**DOCUMENT 00 90 00
ADDENDUM**

ADDENDUM NO. [1] Date: February 16, 2021

**RE: WESTERN TECHNICAL COLLEGE
 SPARTA PUBLIC SAFETY EXPANSION
 11177 COUNTY HWY A
 SPARTA, WISCONSIN 54656
 HSR PROJECT NO. 20028**

FROM: HSR Associates, Inc
 100 Milwaukee Street
 La Crosse, WI 54603
 (608) 784-1830

1 FIRST FLOOR PLAN - AREA B
1/8" = 1'-0"

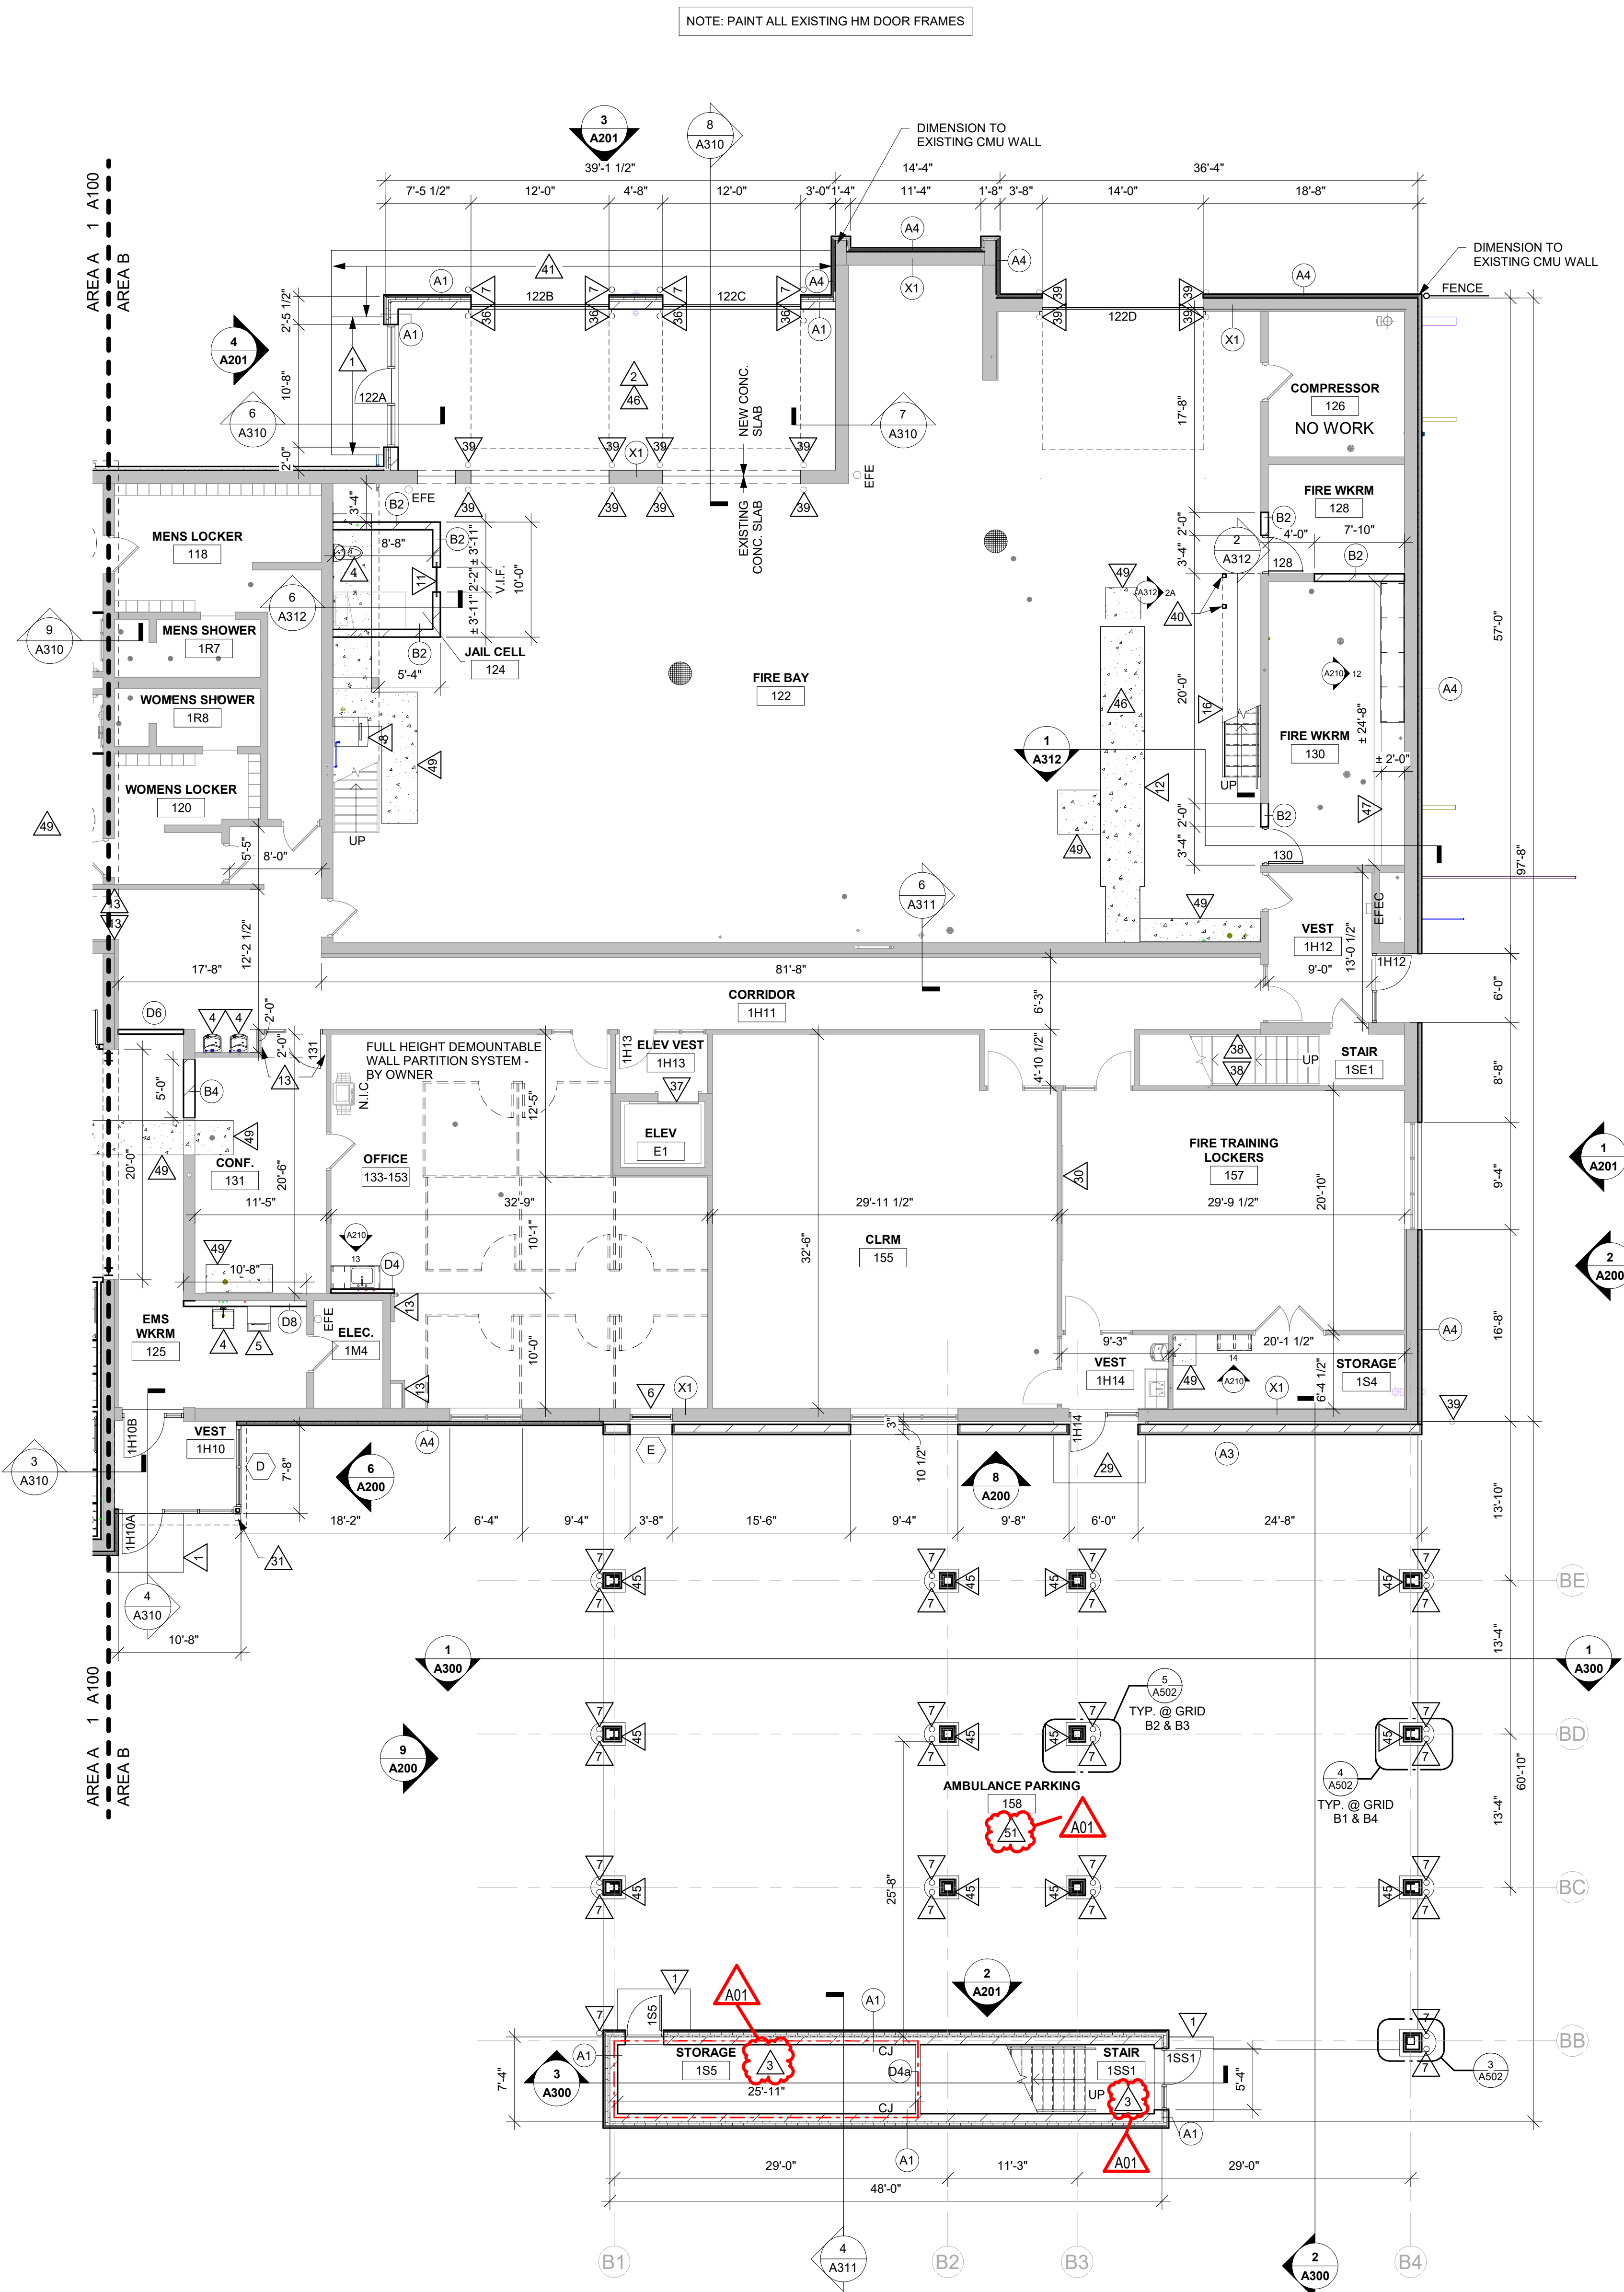
13. Sheet A101 FIRST FLOOR PLAN AREA B 30 x 42 attached hereto
 - a. Revisions clouded on Drawing
 - b. North wall of Ambulance parking: The Work on the exterior side of this wall, under the canopy between Grids B1 and B4 shall be included in the Base Bid amount.

1 SECOND FLOOR PLAN
1/8" = 1'-0"

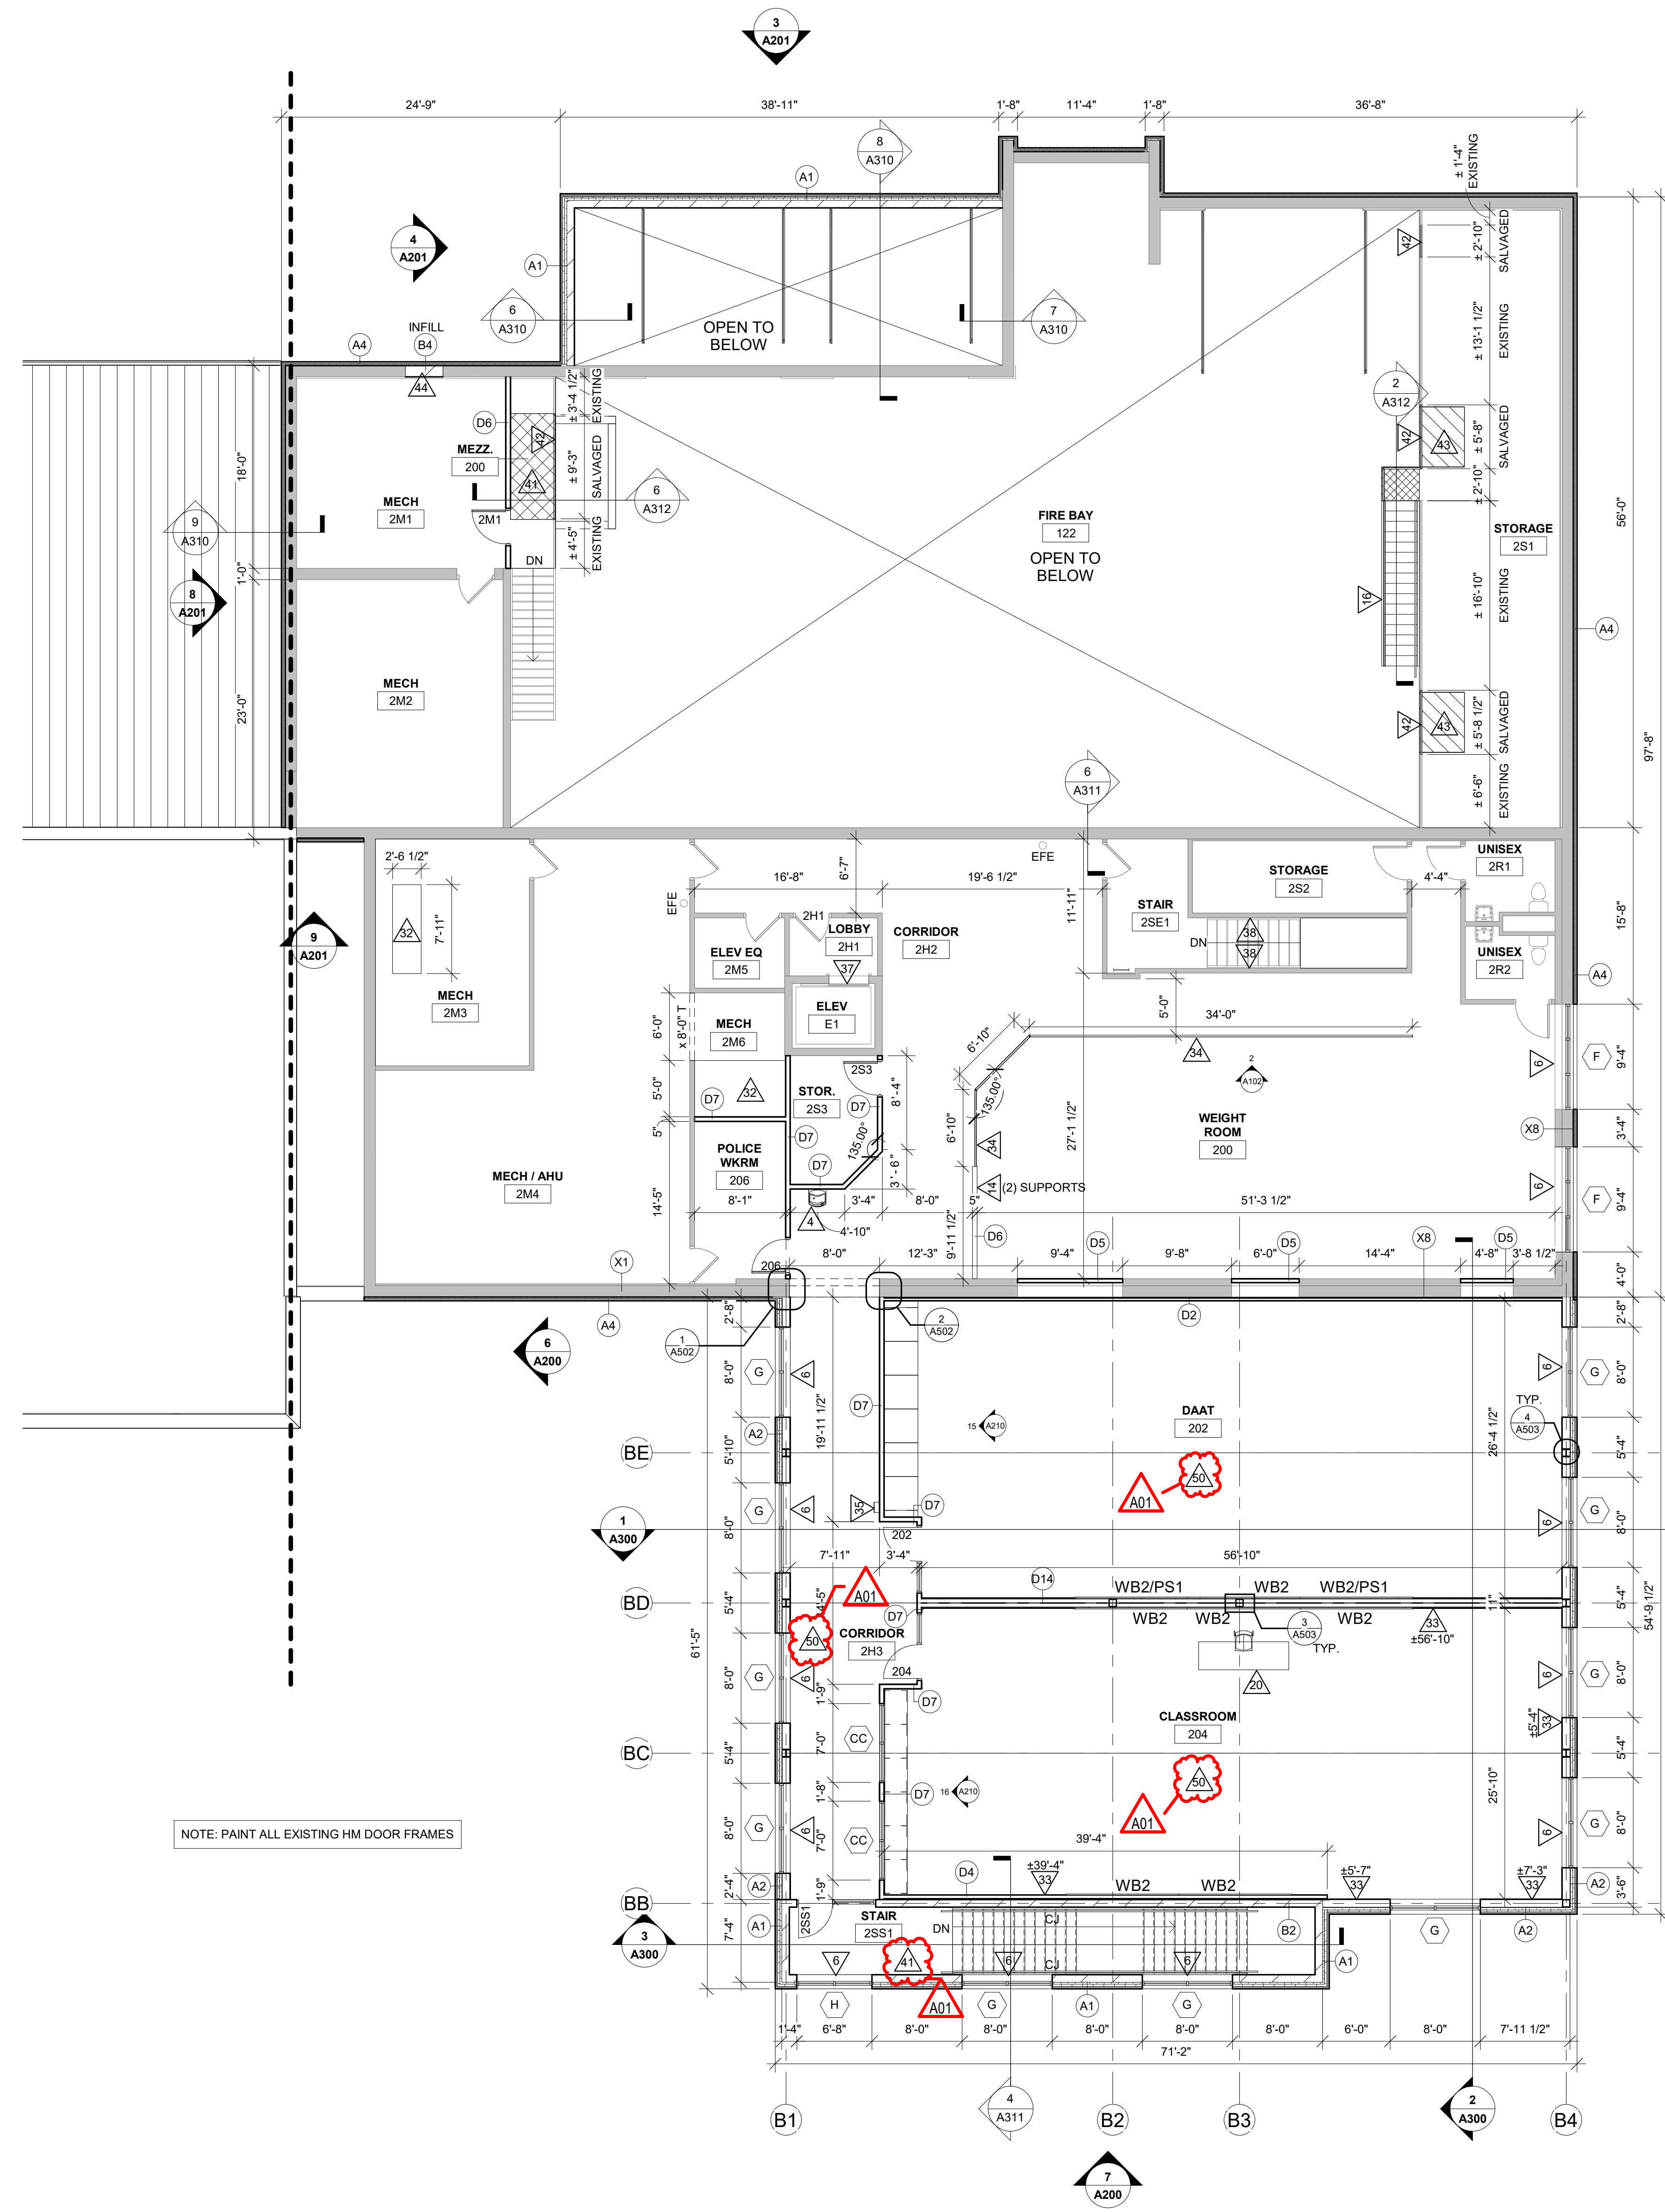
14. Sheet A102 SECOND FLOOR PLAN 30 x 42 attached hereto
 - a. Revisions clouded on Drawing
 - b. Work at north wall on DAAT 202 side shall be included in Base Bid amount.

- c. Work on the Weight Room 200 side of the wall shall be included in the Alternate Bid amount.
15. Sheet A312 WALL SECTIONS (No Drawing reissued)
 - a. 3, 4 and 5A312: Change wall type A2 to A9 over cold formed framing parapet wall. Refer to A600 in this addendum for Wall type A9.

PARTITION TYPE	FIRE RESISTANCE RATING	R-VALUE	NOTES
A7		27.12	
A9		8.0

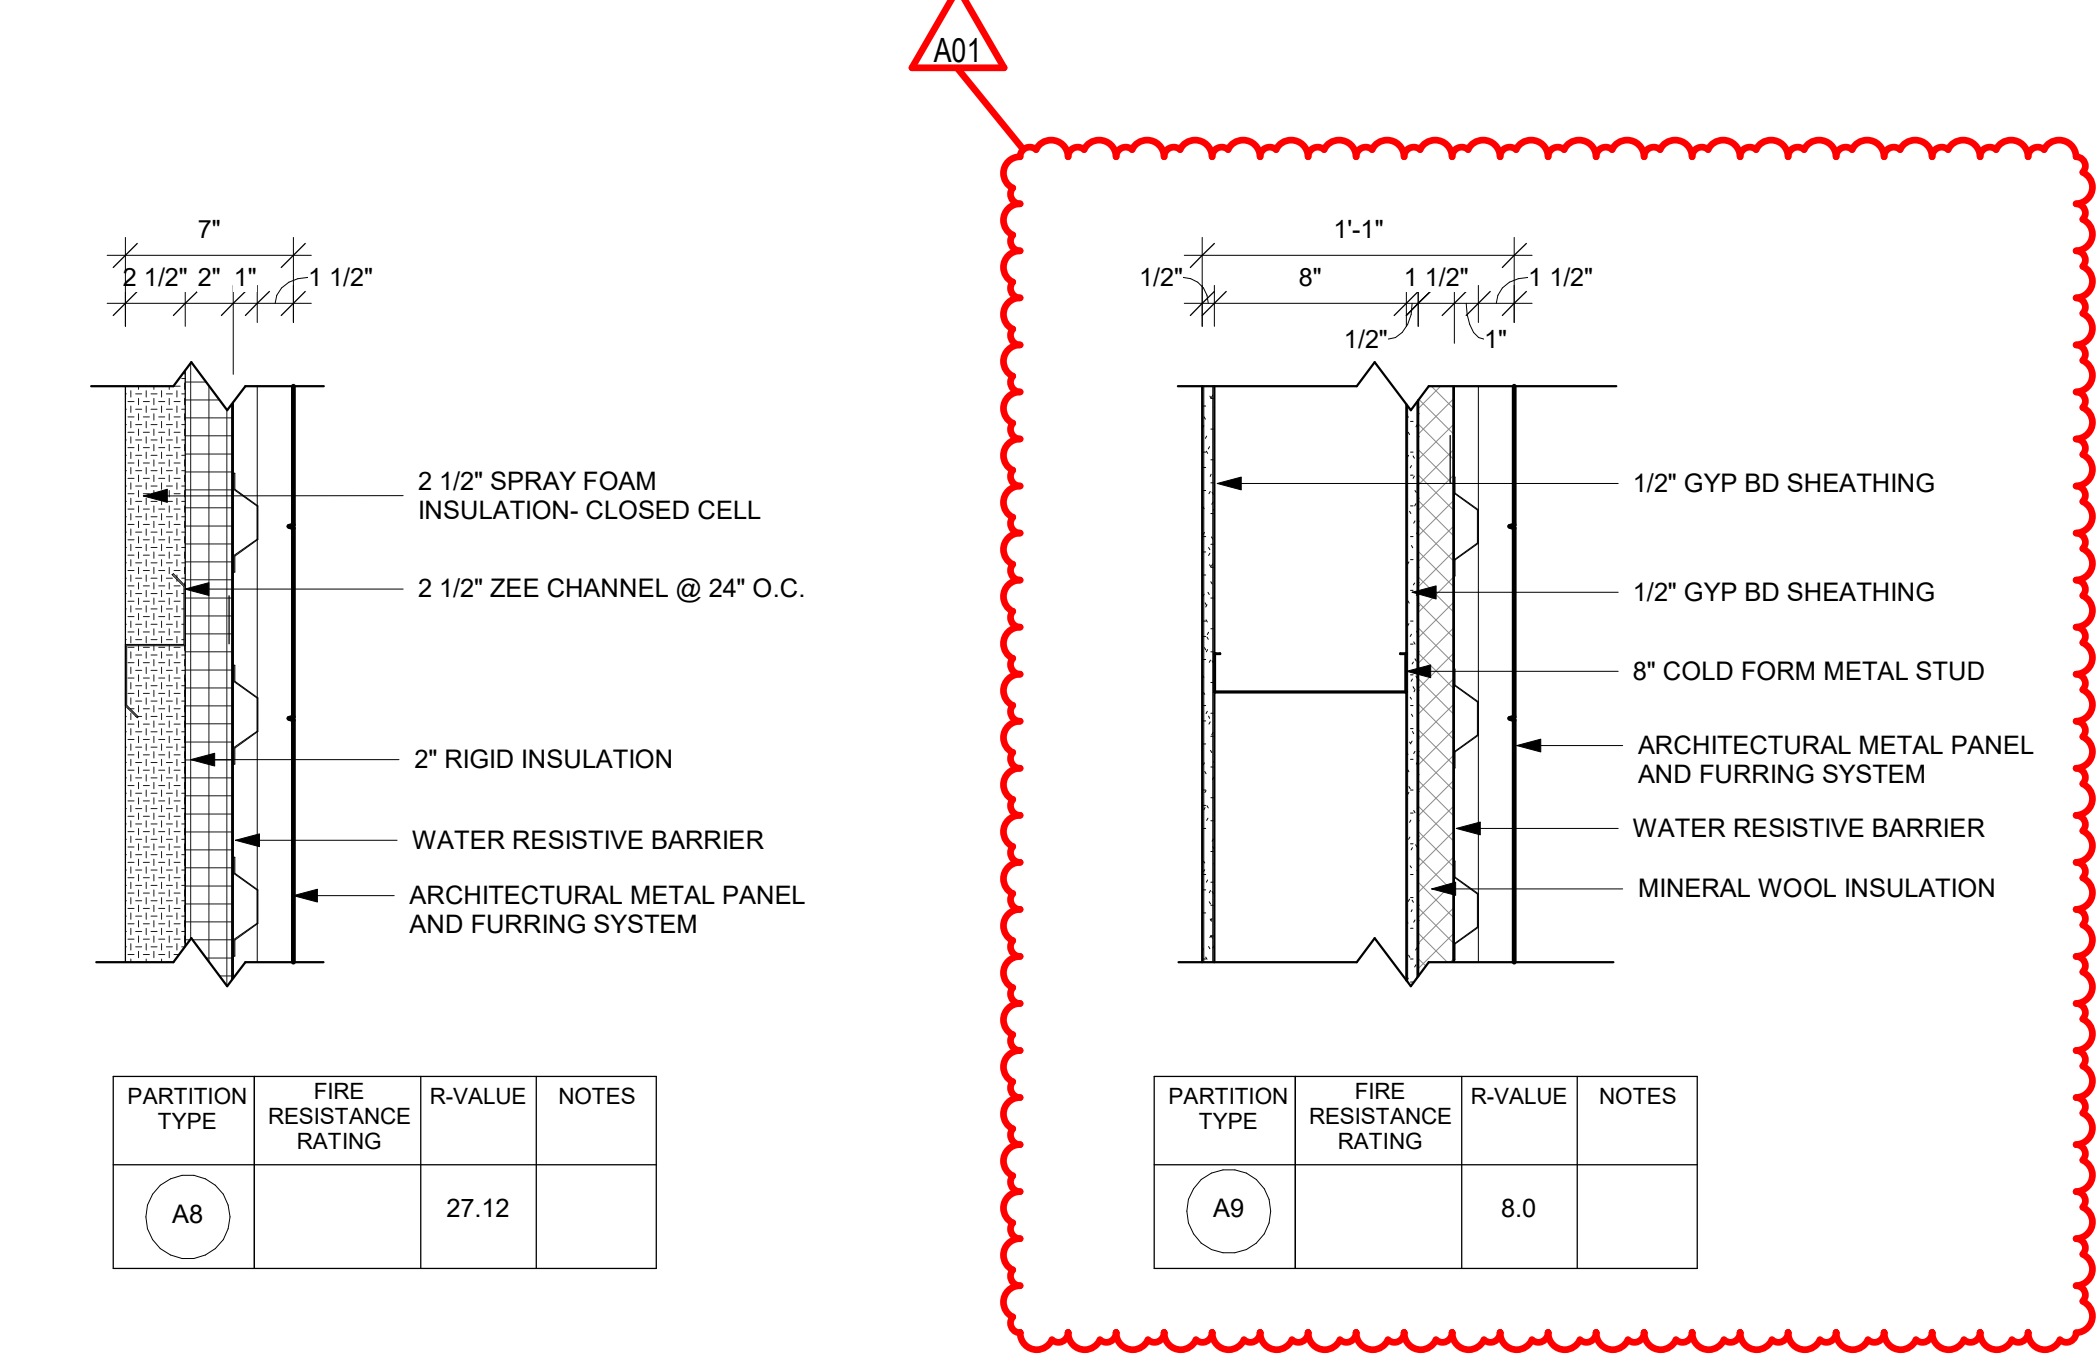
16. Sheet A600 WALL TYPES 30 x 42 attached hereto
 - a. Revisions clouded on Drawing
 - b. Add Wall Type A9.
17. Sheet A601 DOOR SCHEDULE 30 x 42 attached hereto
